Item Name: Crosstube Aft

DART AEROSPACE LTD		Work Order:	81481
Description: Crosstube High Aft (407)		Part Number:	D407-667-205
Inspection Dwg: D407-667-245 Rev: F		Page 1 of 1

DRAWING NO. D407-667-245	TITLE CROSSTUBE ASSY (407 HIGH AFT)	REV. F	DART AEROSPACE LTD ENGINEERING ORDER		D.E.O. NO. D407-667-245-F-1	SHEET NO. SHEET 1 OF 2	SCALE NTS
DRAWN <i>[Signature]</i>	CHECKED <i>[Signature]</i>	MFG. APPR. <i>[Signature]</i>	APPROVED <i>[Signature]</i>		DE APPR. <i>[Signature]</i>		
DATE 11.04.08	DATE 11.04.12	DATE 11.04.12	DATE 11.04.12		DATE 11.04.12

DRAWING NO. D407-667-245	TITLE CROSSTUBE ASS'Y (407 HIGH AFT)	REV. F	DART AEROSPACE LTD ENGINEERING ORDER		D.E.O. NO. D407-667-245-F-2	SHEET NO. SHEET 1 OF 1	SCALE NTS
DRAWN <i>qp</i>	CHECKED <i>ASS</i>	MFG. APPR. <i>E</i>	APPROVED <i>MP</i>		DE APPR. <i>MP</i>		
DATE 11.09.07	DATE 11.09.19	DATE 11.09.19	DATE 11.09.19		DATE 11.09.19

D407-667-245
ASSEMBLY DETAIL
(VIEW LOOKING FORWARD)

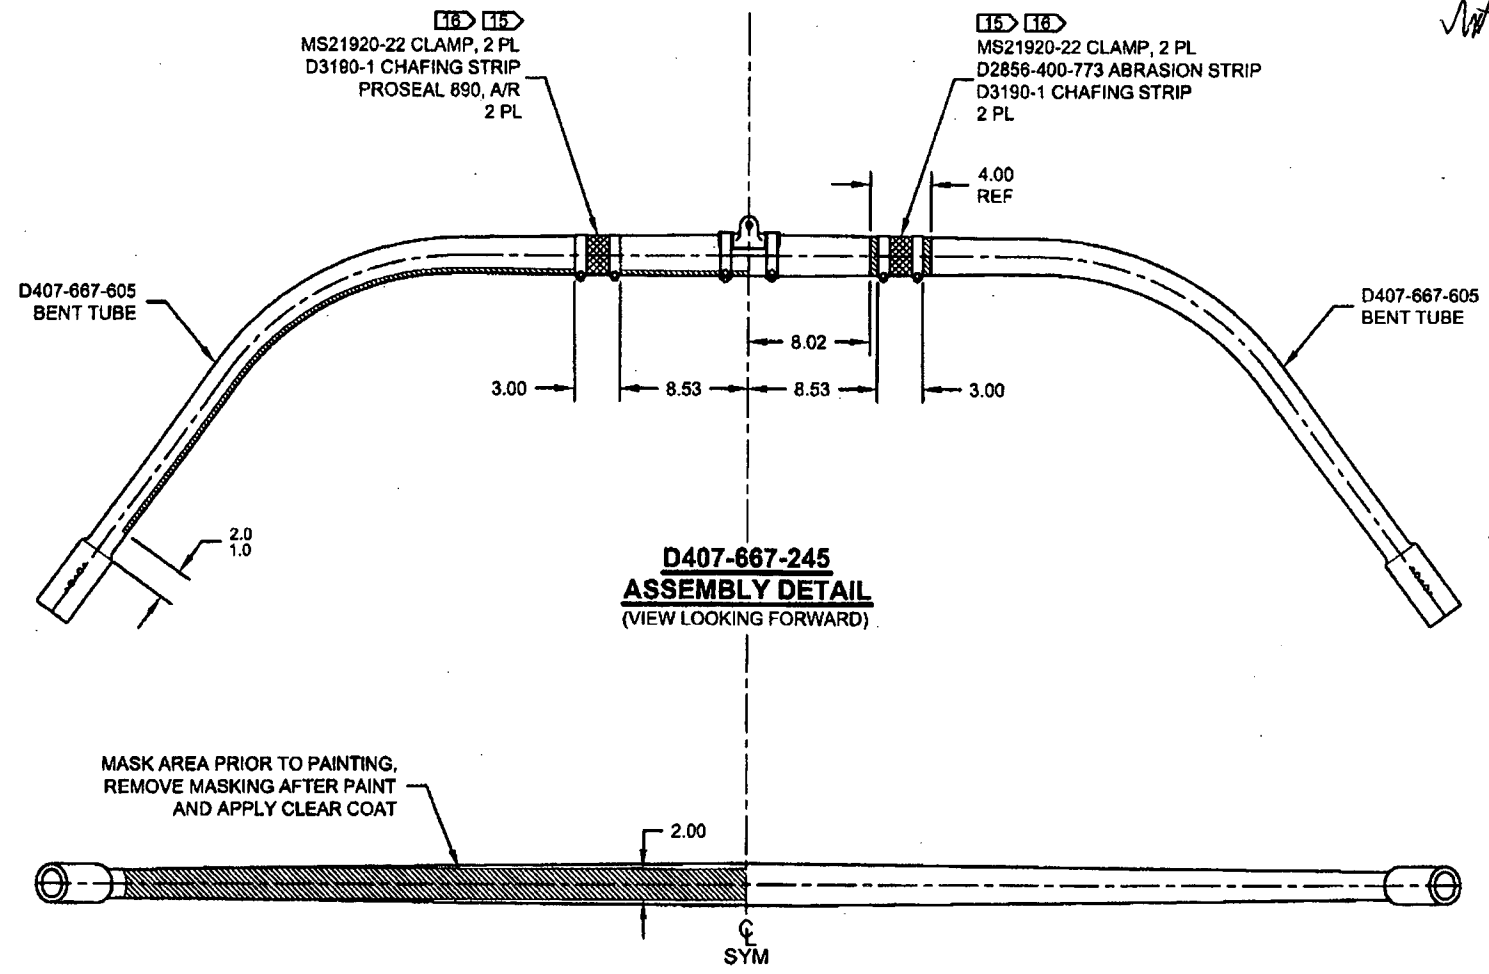
PURPOSE:

REMOVED ABRASION STRIP IN FAVOR OF A THIN LAYER OF PROSEAL 890.

NOTES 2 AND 15, SHEET 1 ARE AMENDED AS FOLLOWS:

- 2) FINISH: CHEMICAL CONVERSION COAT PER DART QSI 005 4.1
PRIME INSIDE AND OUTSIDE PER DART QSI 005 4.2
MASK UNDERSIDE OF CROSSTUBE AS SHOWN (HATCHED AREA) AND
PAINT OUTSIDE PER DART QSI 005 4.2
REMOVE MASKING AND APPLY CLEAR COAT
- 15) APPLY A THIN COAT OF PROSEAL 890 ON INSIDE CONCAVE SURFACE OF D3190-1
CHAFING SHIELDS AND LET CURE PER MANUFACTURER'S INSTRUCTIONS. INSTALL
PROSEALED D3190-1 CHAFING SHIELDS ONTO CROSSTUBE BY APPLYING A THIN COAT
OF PROSEAL 890 ONTO CROSSTUBE. BE SURE TO ELIMINATE ANY AIR GAPS.
